Access Compliance Report

Public Rights-of-Way

(Curb Ramps)

Intersection ID: 10014519	Main Street: UNIVERSITY_POINTE_BV	Cross Street: N/A	Location: SW
ADA ID: B31510E996A6	Ramp Type: Perp	Initial Pass/Fail: Fail	Overall Compliance: No
Severity Score: 10			
Codes/Mitigation Info/Possible Solution		Field Measurements/Component Compliance

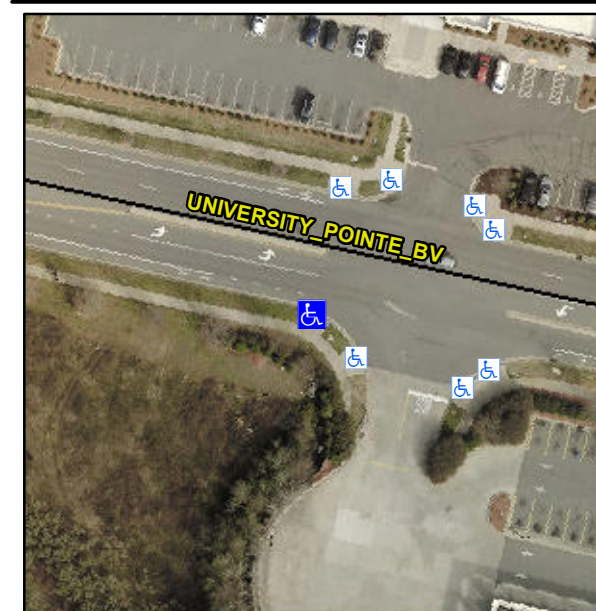
Not Found, R304.5.1

Compliance	Description	Data	Compliance	Description	Data
N/A	Ramp Length (in)	95.0	Yes	Ramp Slope (%)	7.2
No	Ramp Width (in)	47.0	Yes	Ramp XSlope (%)	4.2
N/A	Flare Type LT	N/A	N/A	Flare Type RT	N/A
N/A	Flare Slope LT (%)	N/A	N/A	Flare Slope RT (%)	N/A
N/A	Flare Traversable LT?	N/A	N/A	Flare Traversable RT?	N/A
N/A	Landing Length (in)	N/A	N/A	DWS Provided?	N/A
N/A	Landing Width (in)	N/A	N/A	DWS Contrast?	N/A
N/A	Landing Slope (%)	N/A	N/A	DWS Length (in)	N/A
N/A	Landing X Slope (%)	N/A	N/A	DWS Full Width?	N/A
N/A	Landing Curb? (Y/N)	N/A	N/A	DWS Offset (in)	N/A
N/A	Shared Landing?	N/A			
N/A	Gutter Ponding?	N/A	N/A	Gutter Slope (%)	N/A
N/A	Gutter Lip Ht (in)	N/A	N/A	Gutter X Slope (%)	N/A
N/A	Painted X Walk1?	No	N/A	Painted X Walk2?	N/A
	X Walk 1 Direction	To N		X Walk 2 Direction	N/A
N/A	X Walk 1 Width (in)	N/A	N/A	X Walk 2 Width (in)	N/A
	X Walk 1 Slope (%)	1.4		X Walk 2 Slope (%)	N/A
	X Walk 1 X Slope (%)	6.9		X Walk 2 X Slope (%)	N/A

Remove & Replace Entire Ramp.
